CHANGE: 1. TE M12 4 PIN MALE CONNECTOR ADDED

Released VBV-700C(M12)-C
Part No BE-002904-00-14

VIEW A

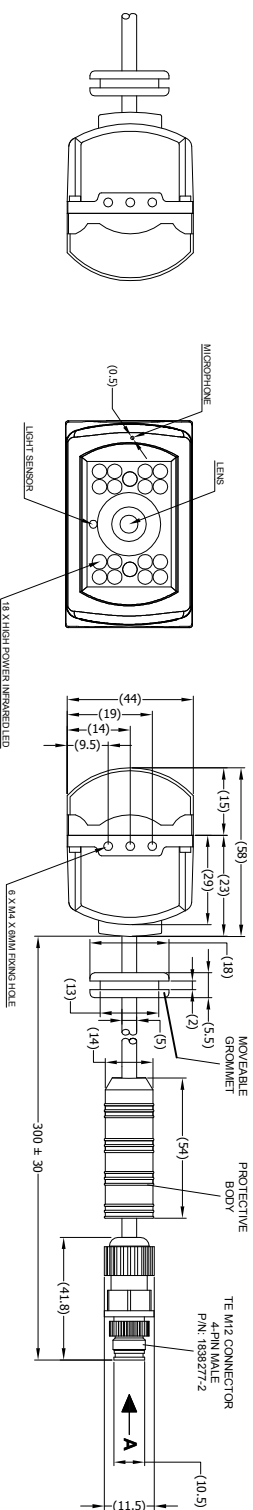
1. TE M12 4 PIN MALE CONNECTOR ADDED.
2. VBV-700C-C PD-LBL REPLACED WITH VBV-700C(M12)-C PD-LBL.

PIN #	WIRE COLOUR	DESCRIPTION
1	SHIELD	GROUND
2	YELLOW	VIDEO SIGNAL
3	RED	12V DC
4	BLACK	GROUND
